# CONSTRUCTION PLANS FOR THE HILLS AT LORSON RANCH FILING NO. 3

## STREET & STORM SEWER CONSTRUCTION PLANS

**THE RIDGE AT LORSON RANCH FIL NO. 3  
STREET & STORM SEWER  
CONSTRUCTION PLANS**

SHEET NUMBER C6.31

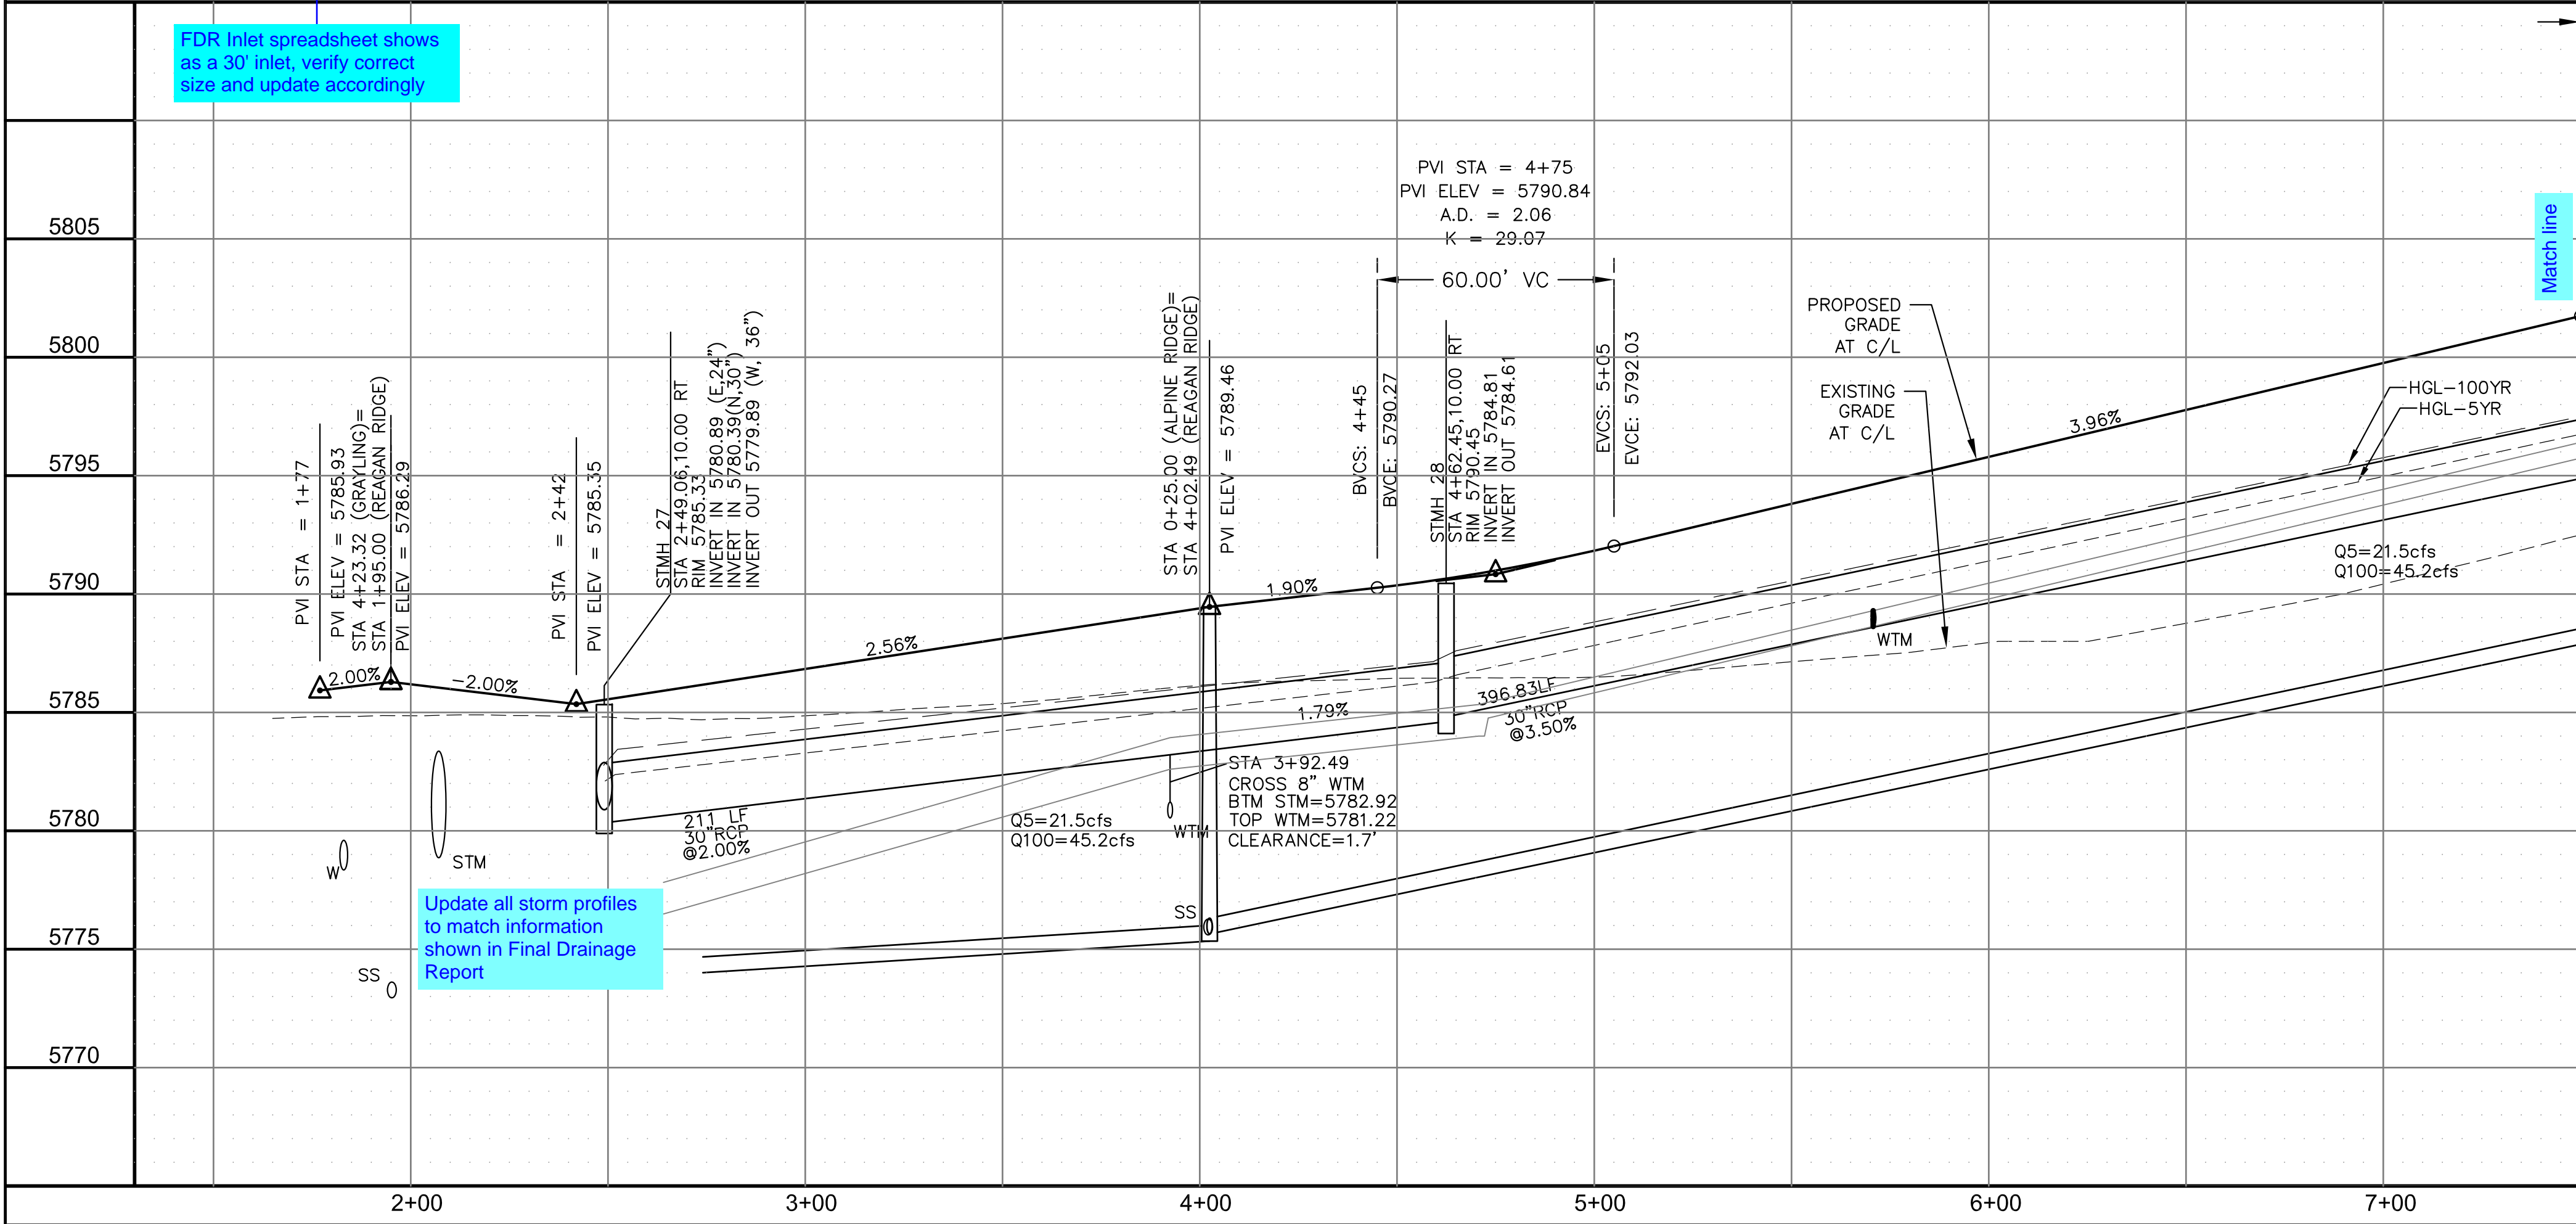
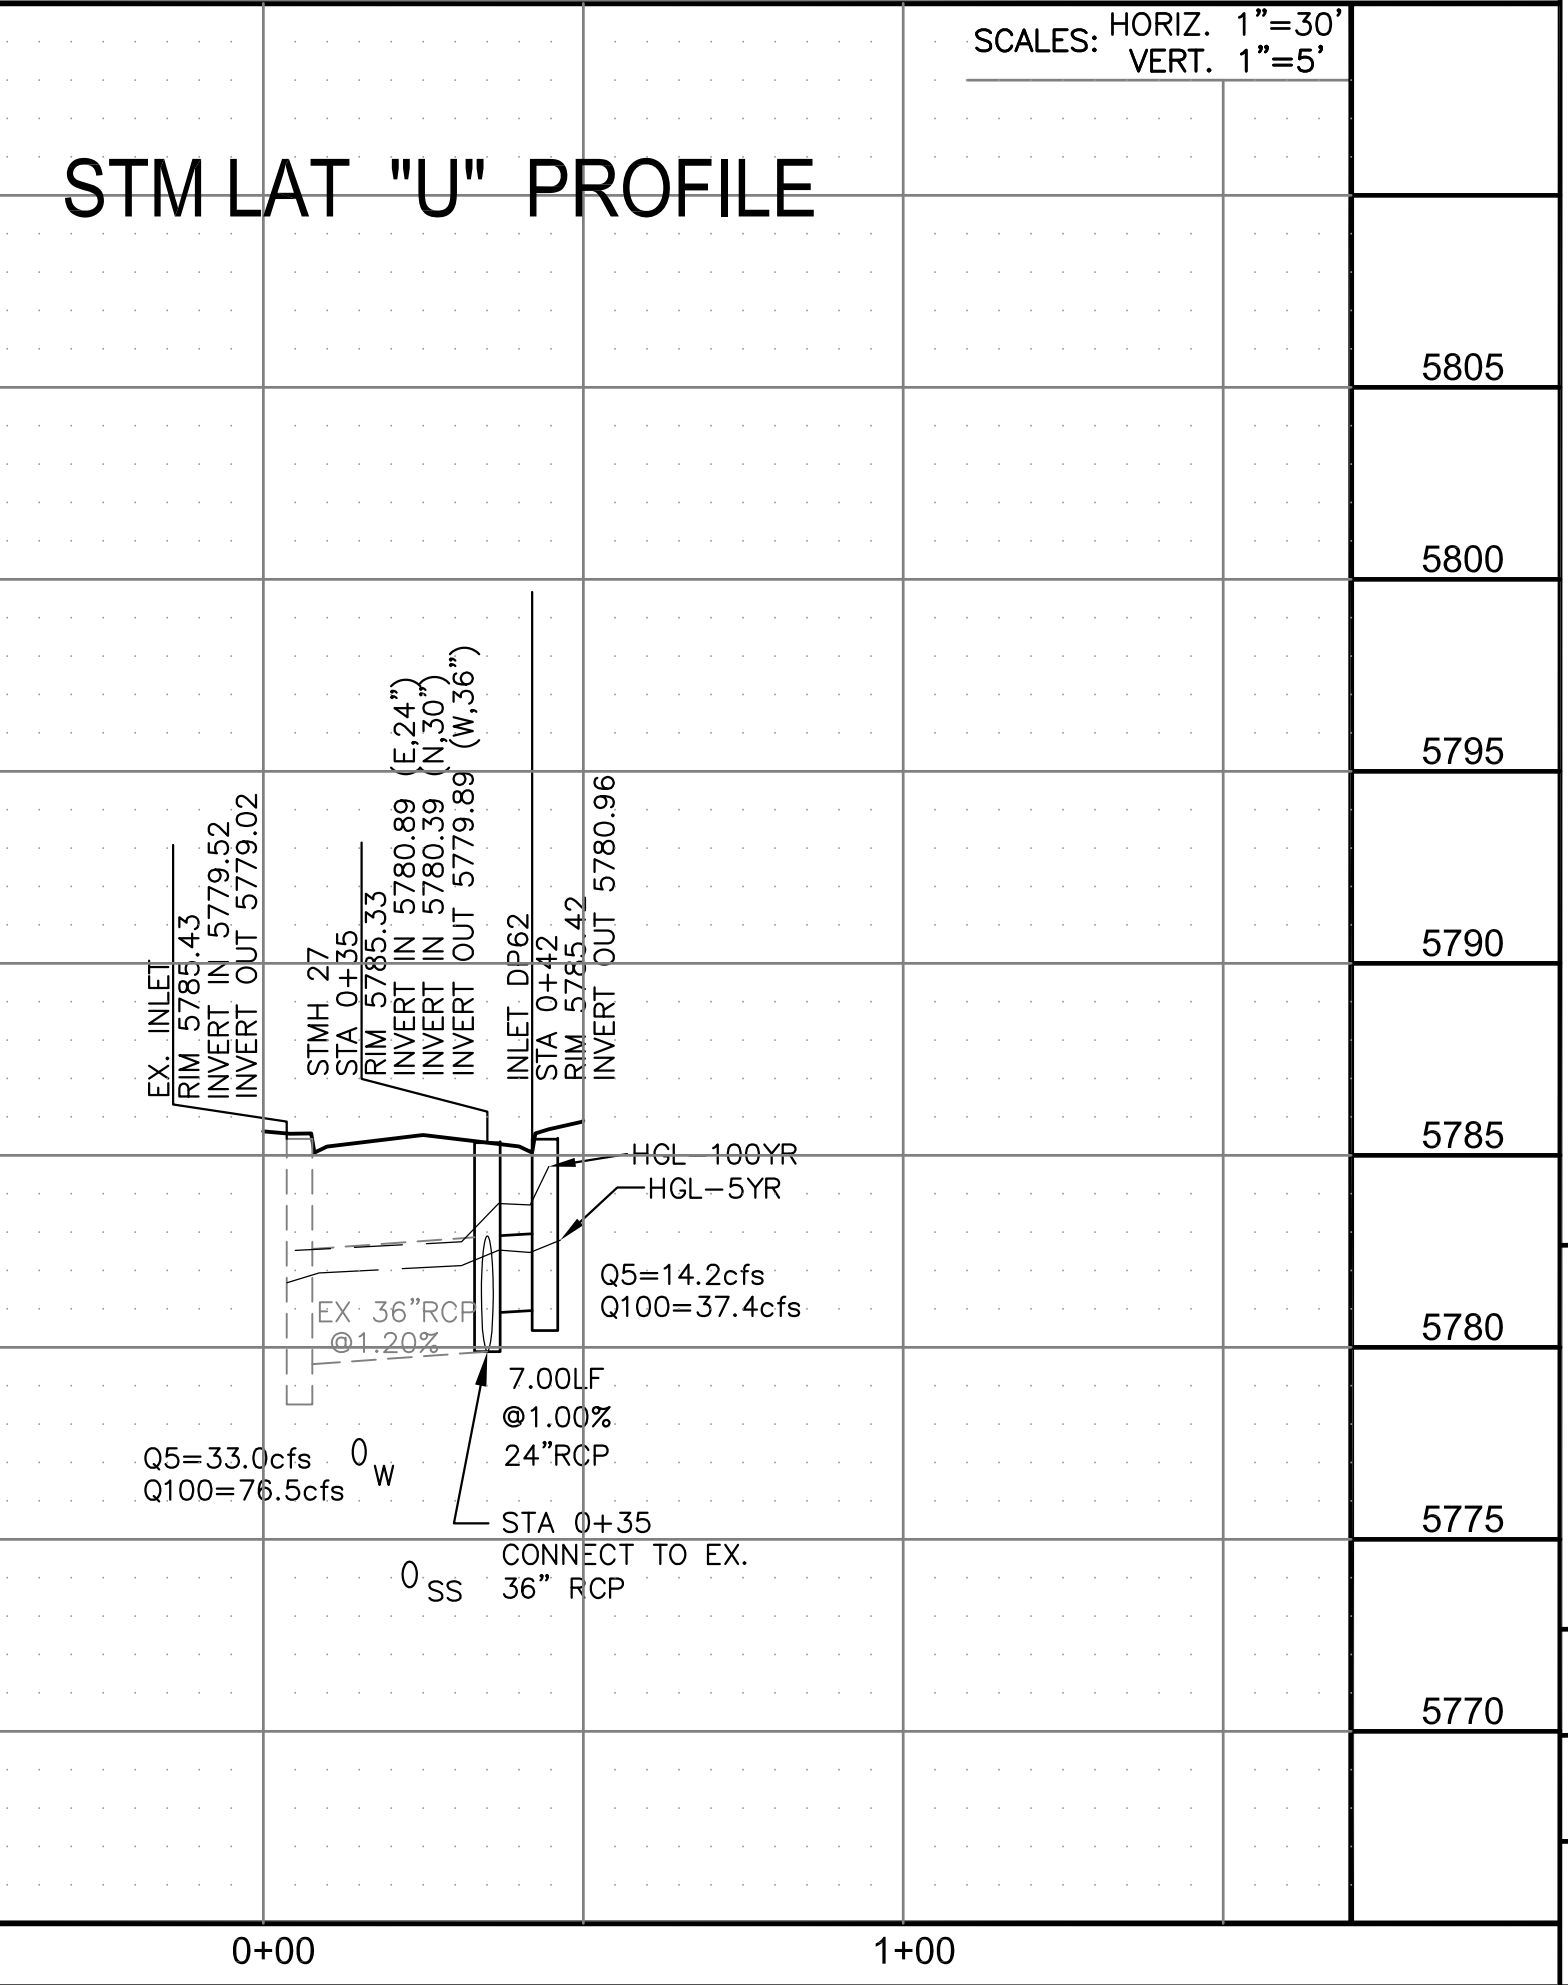
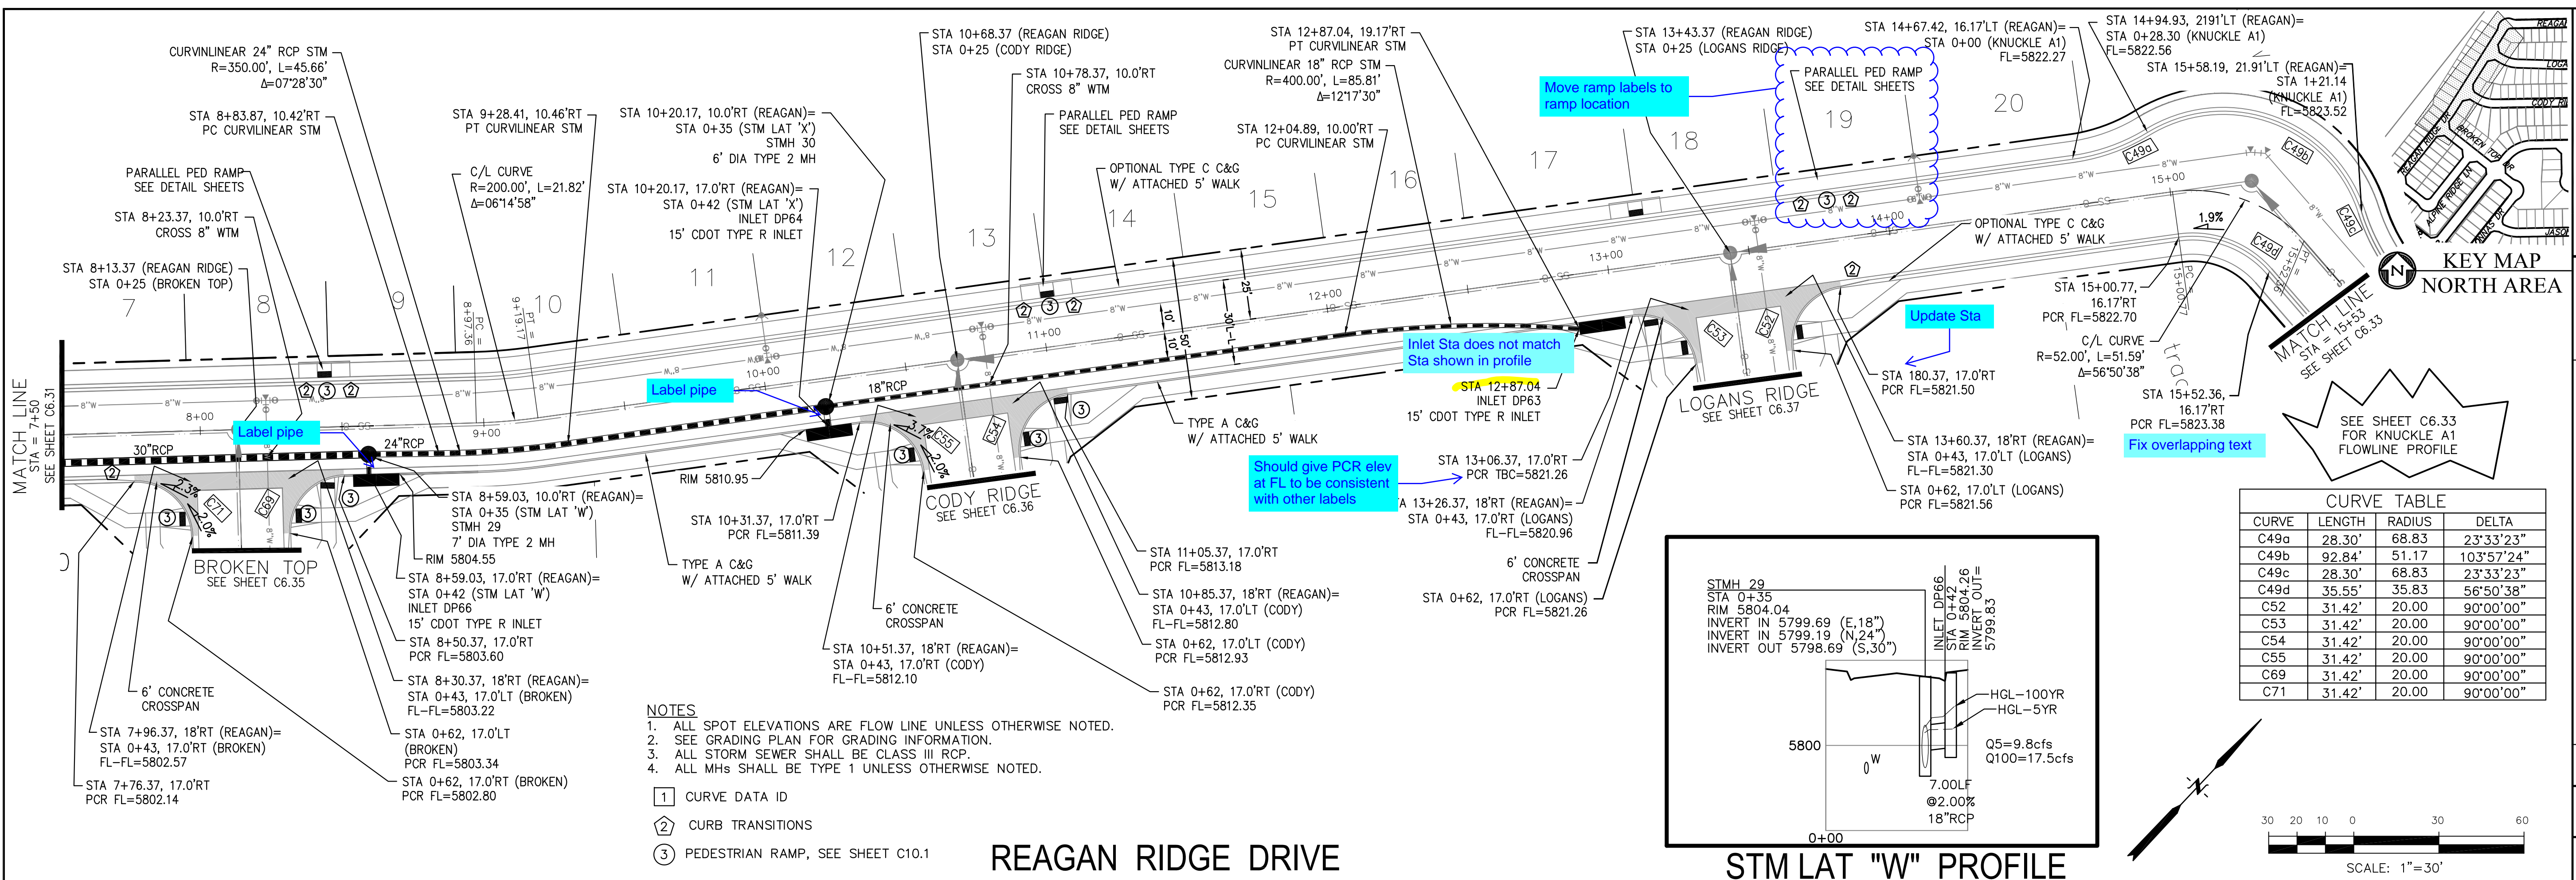
Label all storm facilities at private or public (all sheets)

FDR Inlet spreadsheet shows as a 30' inlet, verify correct size and update accordingly

Update all storm profiles to match information shown in Final Drainage Report

DATE: NOV, 2021  
 PROJECT NO. 100.068  
 SHEET NUMBER C6.32  
 TOTAL SHEETS: 18

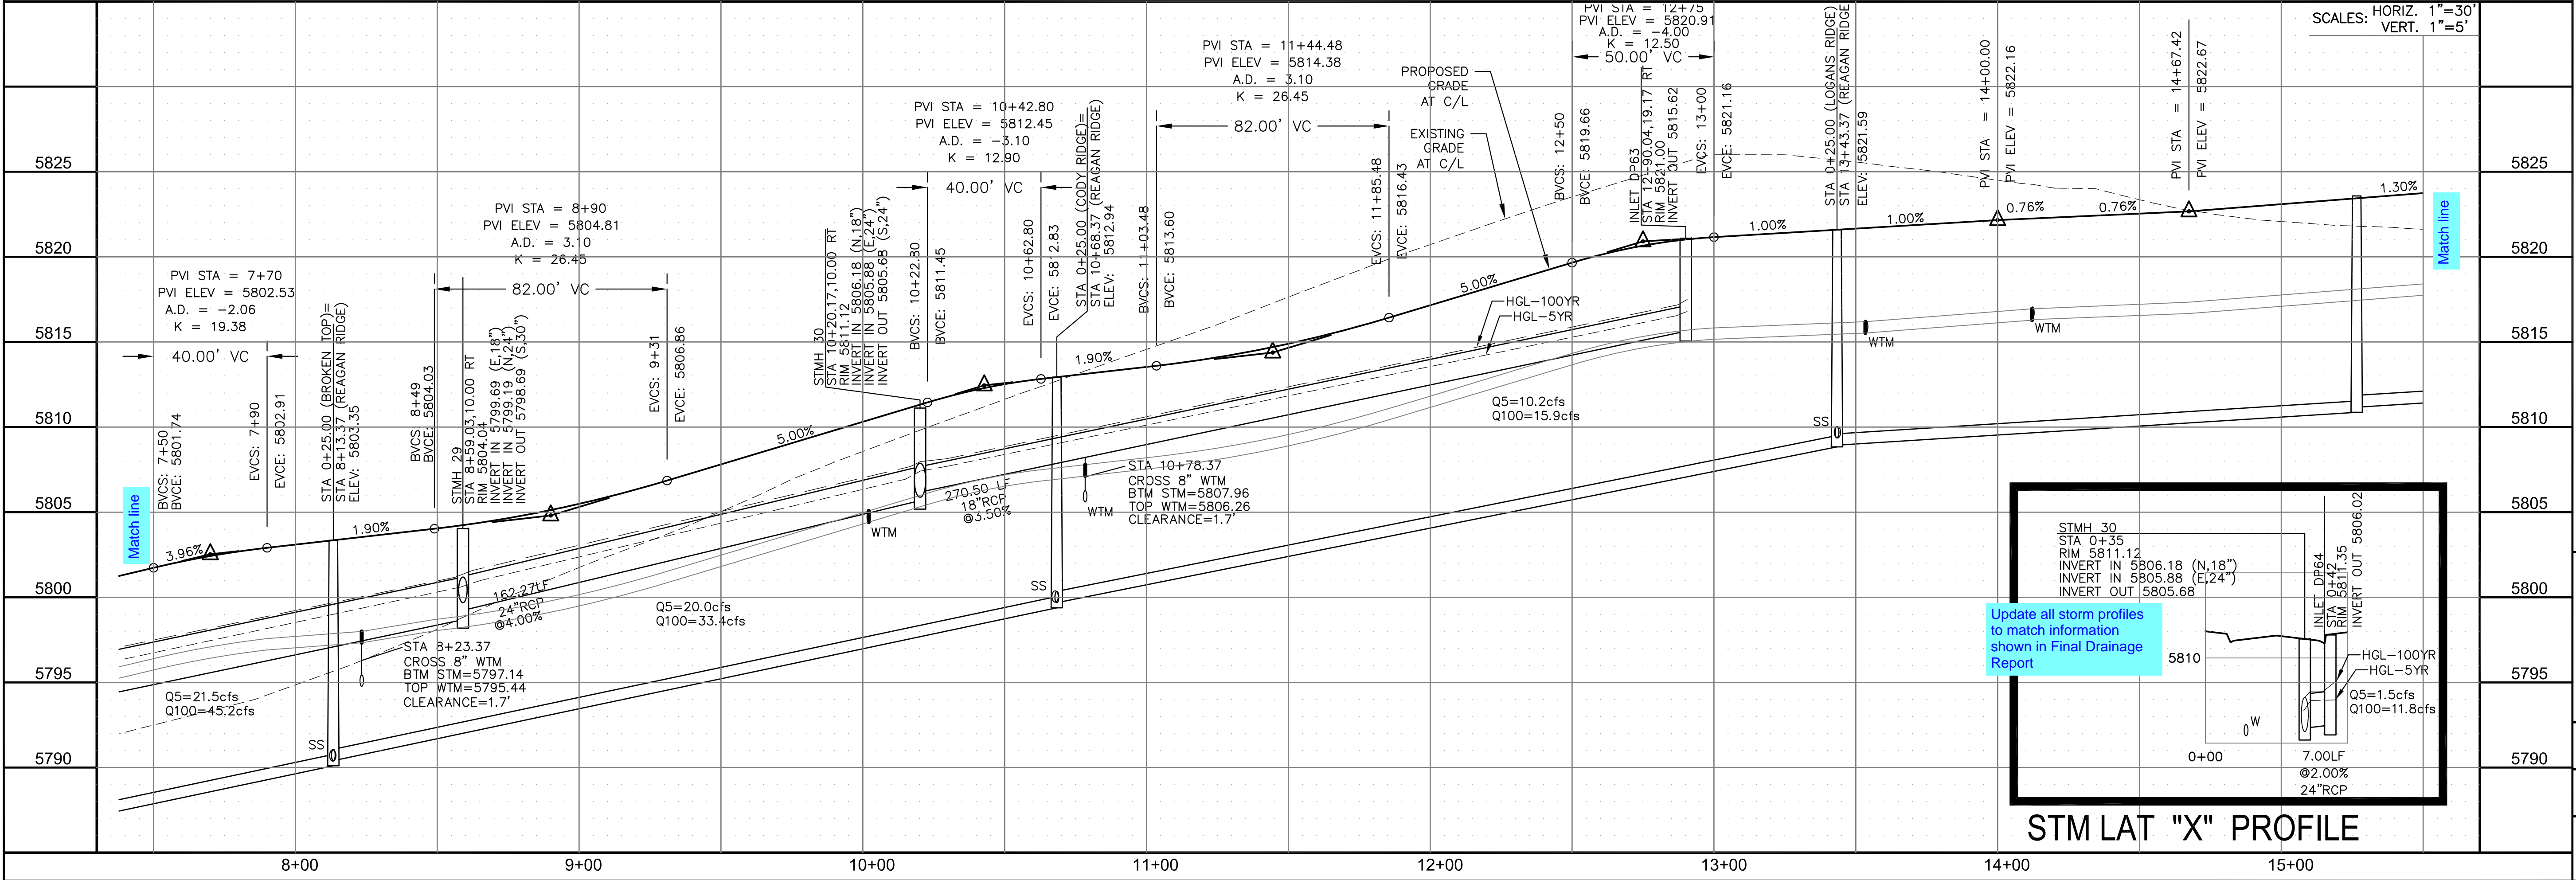
Update all storm profiles to match information shown in Final Drainage Report
